The new rodless cylinder model MCRPL(F)2 is now replacing the MCRPL(F) model, featuring integrated sensor functionality.

1. Model series

MCRPL-Ø16~Ø40 and MCRPLF-Ø16~Ø63.

Product Change Notification
設變通報

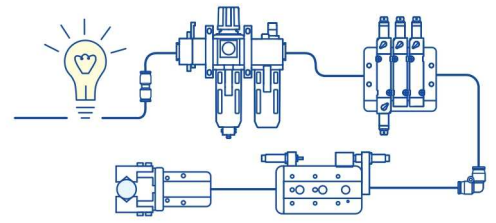
- ◆ Various sensors have been integrated into the RDT model for simplification.
- ◆ Due to a profile change, the old MCRPL(F) model has been replaced by the new MCRPL(F)2 model.
- ◆ In order to be compatible with the new sensor, the profile size of Ø32/Ø40 needs to be changed, as the table displays.

32	48	52																	
40	58	58																	
Tube I.D.	Q1	Q2																	
32	51	52																	
40	59	58.5

3. Change descriptions

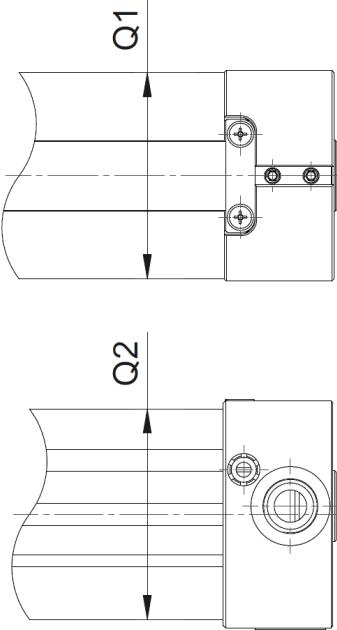
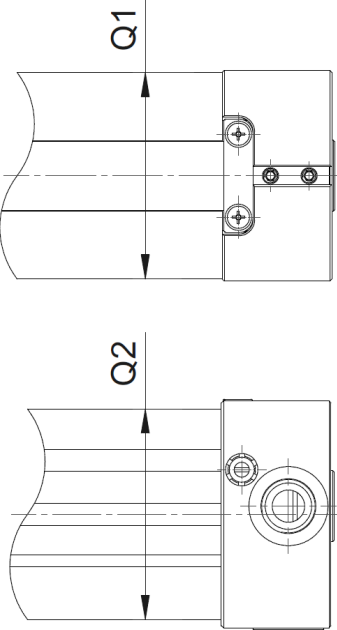
Before	After																		
<p>1. Model :</p> <p style="text-align: center;">MCRPL MCRPLF</p>	<p>1. Model :</p> <p style="text-align: center;">MCRPL2 MCRPLF2</p>																		
<p>2.</p> <div style="text-align: center;">  </div> <table border="1" style="margin-left: auto; margin-right: auto;"> <thead> <tr> <th>Tube I.D.</th> <th>Q1</th> <th>Q2</th> </tr> </thead> <tbody> <tr> <td>32</td> <td>48</td> <td>52</td> </tr> <tr> <td>40</td> <td>58</td> <td>58</td> </tr> </tbody> </table>	Tube I.D.	Q1	Q2	32	48	52	40	58	58	<p>2.</p> <div style="text-align: center;">  </div> <table border="1" style="margin-left: auto; margin-right: auto;"> <thead> <tr> <th>Tube I.D.</th> <th>Q1</th> <th>Q2</th> </tr> </thead> <tbody> <tr> <td>32</td> <td>51</td> <td>52</td> </tr> <tr> <td>40</td> <td>59</td> <td>58.5</td> </tr> </tbody> </table>	Tube I.D.	Q1	Q2	32	51	52	40	59	58.5
Tube I.D.	Q1	Q2

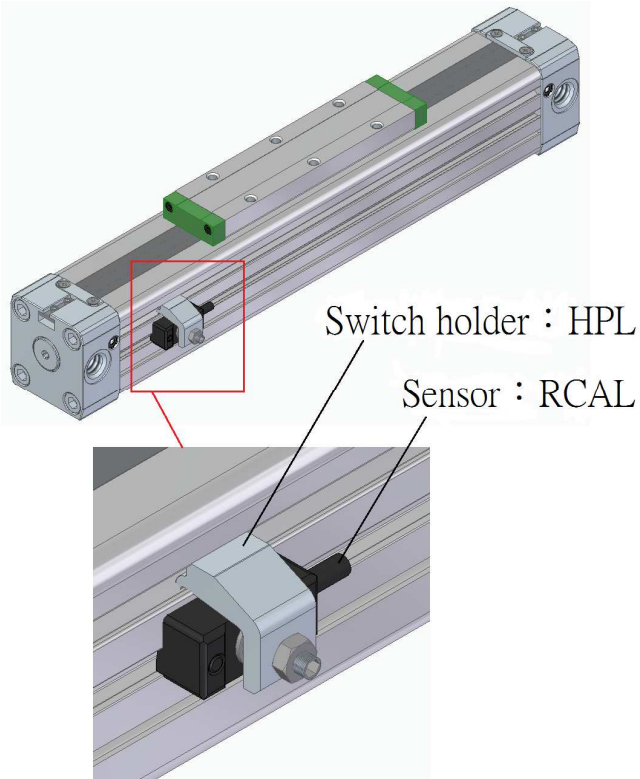
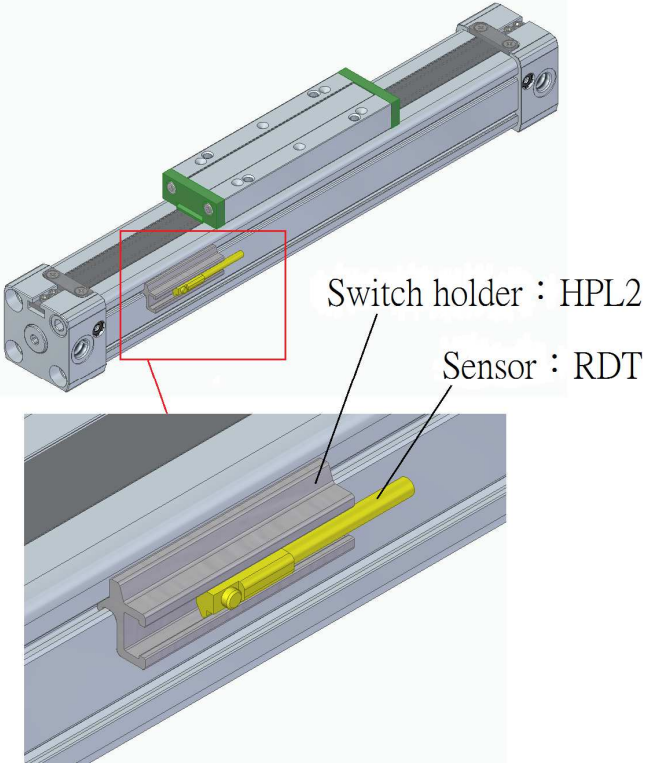
Before	After	
<p>MCRPLF-Ø16~Ø63 sensor</p> 	<p>MCRPLF2-Ø16 / Ø25 sensor</p> 	<p>MCRPLF2-Ø32~Ø63 sensor</p>
